# Access Compliance Report

## Public Rights-of-Way

Intersection ID: 51011	Main Street: TREMONT_PLACE_RD	Cross Street: BENDING_BRANCH_RD	Location: W
ADA ID: CCFA2A922E9B	Ramp Type: Perp	Initial Pass/Fail: Fail	Overall Compliance: No
Severity Score: 22.5			
Codes/Mitigation Info/Possible Solution		Field Measurements/Component Compliance

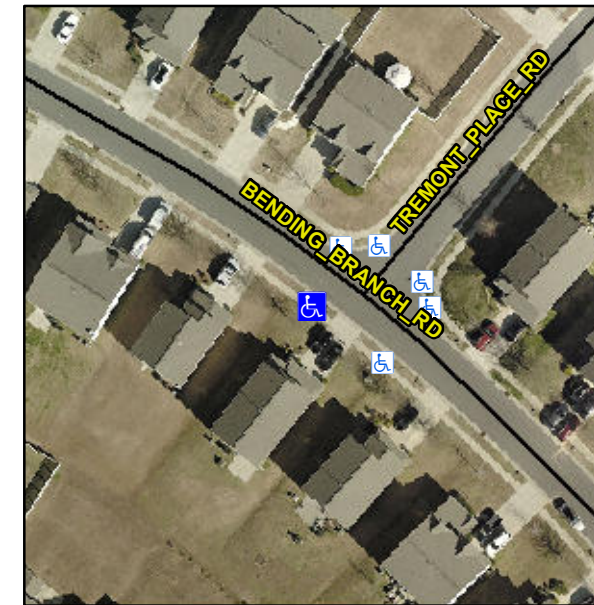
**Not Found, R304.5.1, R304.2.2, R304.5.3**

Compliance	Description	Data	Compliance	Description	Data
N/A	Ramp Length (in)	48.0	No	Ramp Slope (%)	9.5
No	Ramp Width (in)	47.5	No	Ramp XSlope (%)	3.1
N/A	Flare Type LT	N/A	N/A	Flare Type RT	N/A
N/A	Flare Slope LT (%)	N/A	N/A	Flare Slope RT (%)	N/A
N/A	Flare Traversable LT?	N/A	N/A	Flare Traversable RT?	N/A
N/A	Landing Length (in)	N/A	N/A	DWS Provided?	N/A
N/A	Landing Width (in)	N/A	N/A	DWS Contrast?	N/A
N/A	Landing Slope (%)	N/A	N/A	DWS Length (in)	N/A
N/A	Landing X Slope (%)	N/A	N/A	DWS Full Width?	N/A
N/A	Landing Curb? (Y/N)	N/A	N/A	DWS Offset (in)	N/A
N/A	Shared Landing?	N/A			
N/A	Gutter Ponding?	N/A	N/A	Gutter Slope (%)	N/A
N/A	Gutter Lip Ht (in)	N/A	N/A	Gutter X Slope (%)	N/A
N/A	Painted X Walk1?	No	N/A	Painted X Walk2?	N/A
	X Walk 1 Direction	To NE		X Walk 2 Direction	N/A
N/A	X Walk 1 Width (in)	N/A	N/A	X Walk 2 Width (in)	N/A
	X Walk 1 Slope (%)	1.5		X Walk 2 Slope (%)	N/A
	X Walk 1 X Slope (%)	2.8		X Walk 2 X Slope (%)	N/A

**Remove & Replace Entire Ramp.**
